# NOTICE OF DECISION

## SITE PLAN REVIEW / CRITICAL AREAS PERMIT

**Project Title: Columbia River Carbonates rail spur extension**

**Land Use Application No.: 215-934.SPR.CAP.SEPA**

PIPE CASING DETAILS					W-16
APPROVED	REVISIONS	DATE	DRAWN	DESIGNED	
<i>Barbara Wallis</i>					
PUBLIC WORKS DIRECTOR	DATE

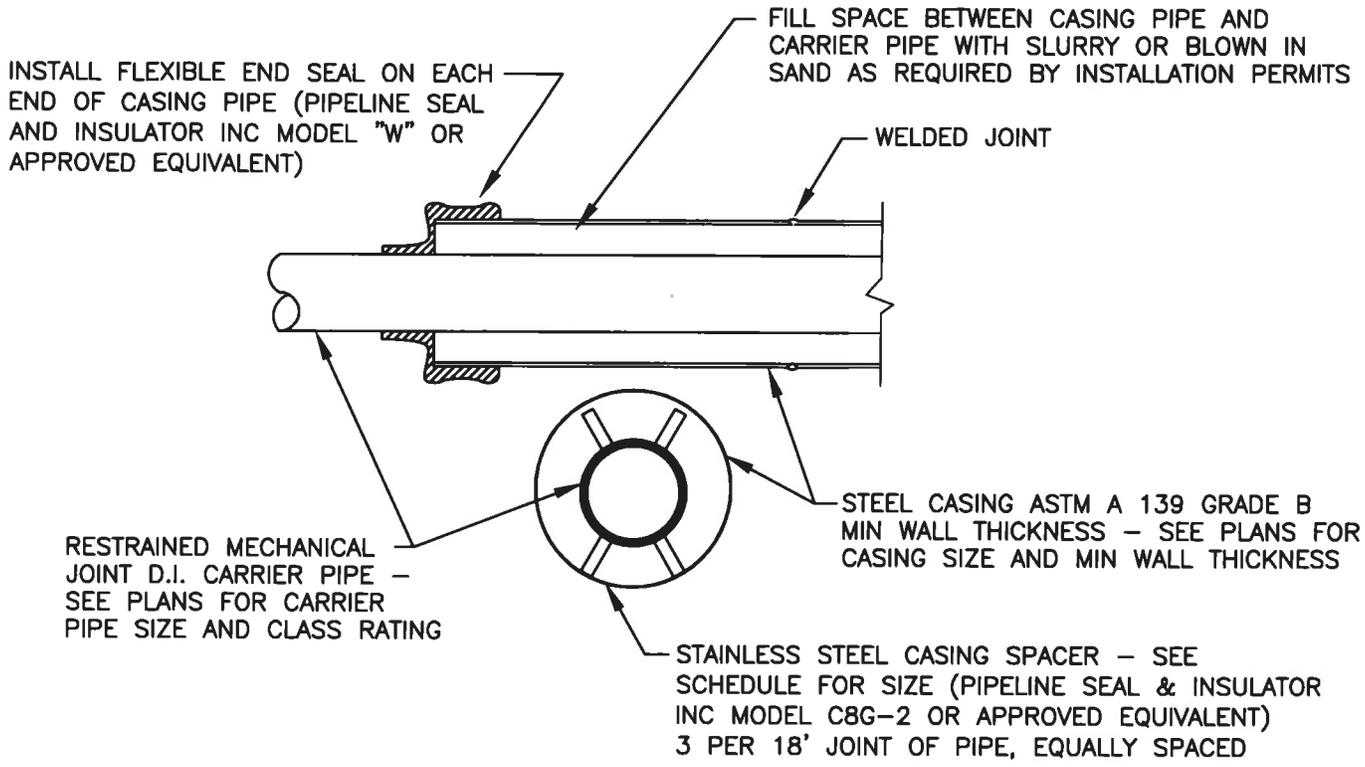
7. The casing for the water line needs to be 24", not 18". See the attached detail W-16. This detail should be included in the drawings.
8. The top of the waterline casing is shown at 6' deep, which is significantly deeper than typical waterlines. If this depth is a requirement for railroad crossings please explain that in the drawings. If not, please raise the casing up a couple feet. It looks like the casing could be 4' deep and not interfere with any other pipes based on the drawings provided.

CASING SIZING REQUIREMENTS

CARRIER PIPE	MINIMUM CASING REQUIREMENTS	WALL THICKNESS
4"	16" A36 STEEL	3/8"
6"	16" A36 STEEL	3/8"
8"	24" A36 STEEL	3/8"
10"	24" A36 STEEL	3/8"
12"	24" A36 STEEL	3/8"
16"	36" A36 STEEL	5/8"
24"	48" A36 STEEL	5/8"

1. CASING TO BE EXTENDED 5' BEYOND ANY CURBS, WALLS, STRUCTURES, OR FOOTINGS.
2. PUBLIC AND PRIVATE MAINS SHALL BE PLACED IN SEPARATE CASINGS.
3. FOR CASINGS UNDER RAILROAD TRACKS, WRITTEN PERMISSION FOR THE OWNER OF THE RAILROAD TRACKS IS REQUIRED PRIOR TO OBTAINING CITY OF WOODLAND PERMITS TO PROCEED.
4. NO PRIVATE UTILITIES SHALL BE ALLOWED IN CITY OF WOODLAND CASINGS.
